## Sydney South West Planning Panel

<b>Panel Reference</b>	2016SSW243
<b>DA Number</b>	3280/2016/DA-RA
<b>LGA</b>	Campbelltown
<b>Proposed Development</b>	Demolition of existing structures, construction of a 10 storey residential apartment building consisting of 105 residential units, basement car parking, 2 retail/commercial units and a boundary adjustment
<b>Street Address</b>	Lot 3 DP 575491, 28 Cordeaux Street Lot 50 DP 811930, 12 Cordeaux Street Lot 51 DP 811930, 5 Howe Street Campbelltown
<b>Applicant</b>	Campbelltown No. 1 Property Developments Pty Ltd
<b>Owner</b>	Campbelltown No. 1 Property Developments Pty Ltd (lot 3) Anglican Church Property Trust Diocese of Sydney (lots 50 and 51)
<b>Date of DA lodgement</b>	10 October 2016
<b>Number of Submissions</b>	Twenty-nine
<b>Recommendation</b>	Refusal
<b>Regional Development Criteria</b>	Development that has a capital investment value of more than \$20 million The CIV is \$29.9 million

<b>Report prepared by</b>	Mr D. Timmins – Development Assessment Planner Campbelltown City Council
<b>Report date</b>	29 September 2017

**Figure 8: Pedestrian access to Rectory**

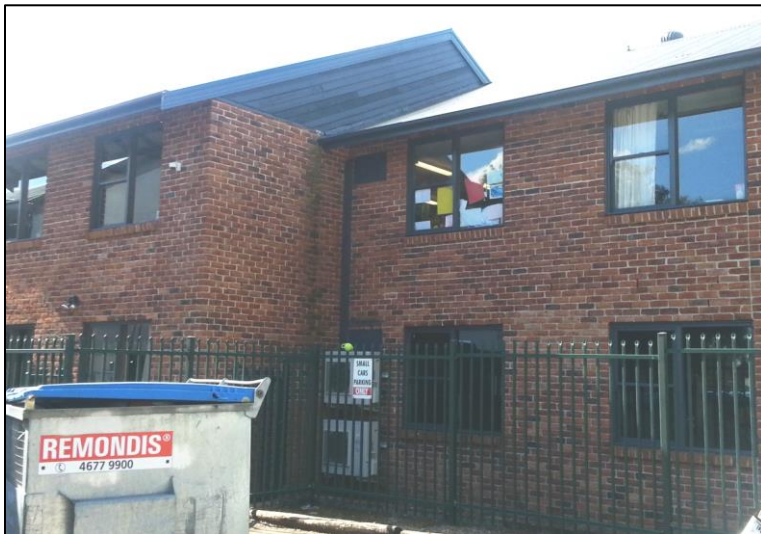
The proposed driveway would result in a level change of 0.7m – 0.98m between the proposed driveway and the fence entry to the rectory. It is proposed construct a timber retaining wall adjacent to the fence. The proposed level change and retaining wall would remove level pedestrian access to the rectory that is not compatible with the heritage item.

Figure 13: North-eastern façade of building facing school property

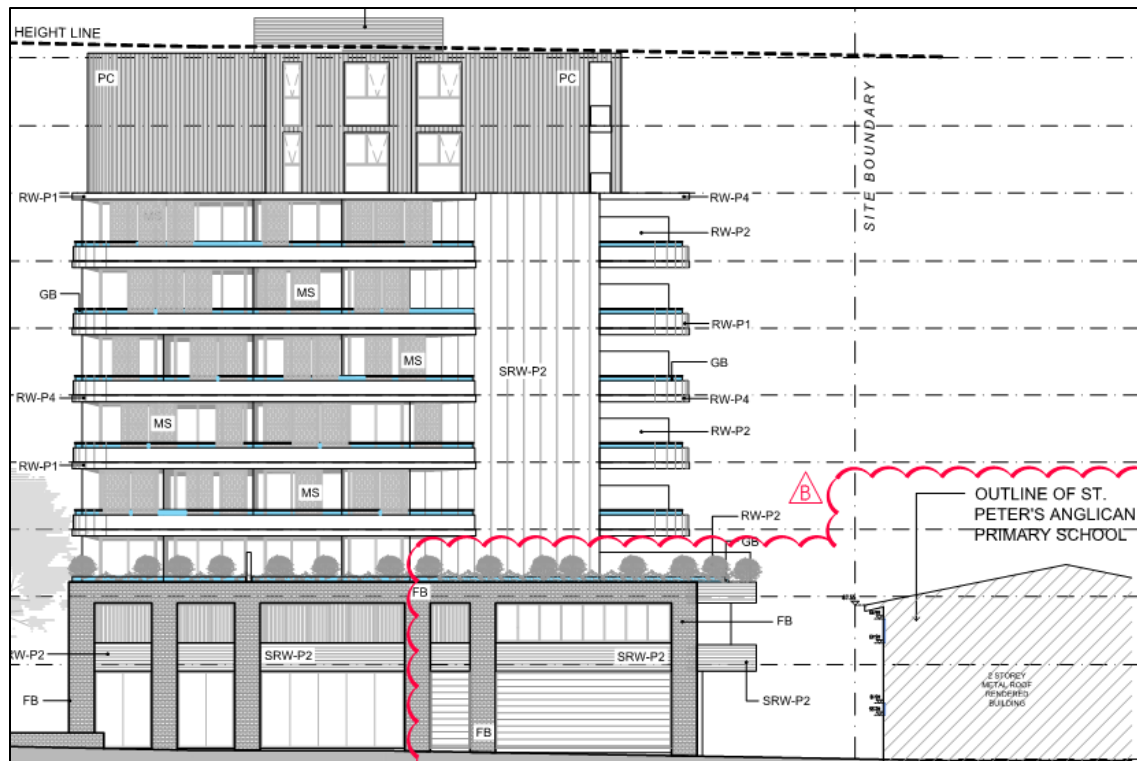
The proposed development in its current form fails to achieve the objective for building separation in the ADG. A compliant building separation would provide better visual and acoustic privacy for future residents and occupants of the adjoining school buildings. The non-compliant building separation does not increase the amenity of the apartment and unduly compromises the visual privacy of the adjoining school property.

Figure 14: Location of building showing overlooking potential to adjoining school buildings and playground

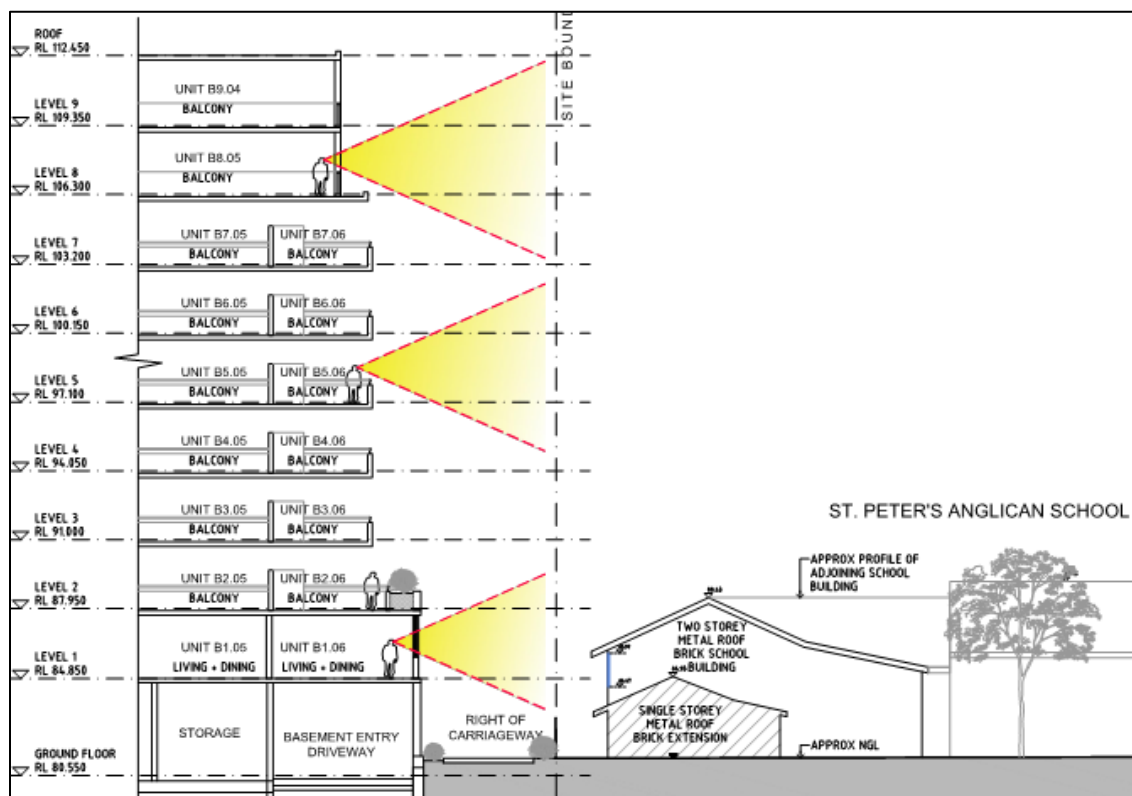
The design of the building would not provide a compatible land use as it does not appropriately respond to the sensitive land uses being the adjoining school and heritage item. The failure to provide adequate separation distances, deep soil planting and outdoor communal open space at ground level between the school is not considered satisfactory and contributes to significant adverse overlooking to the adjoining playground and windows of school buildings.
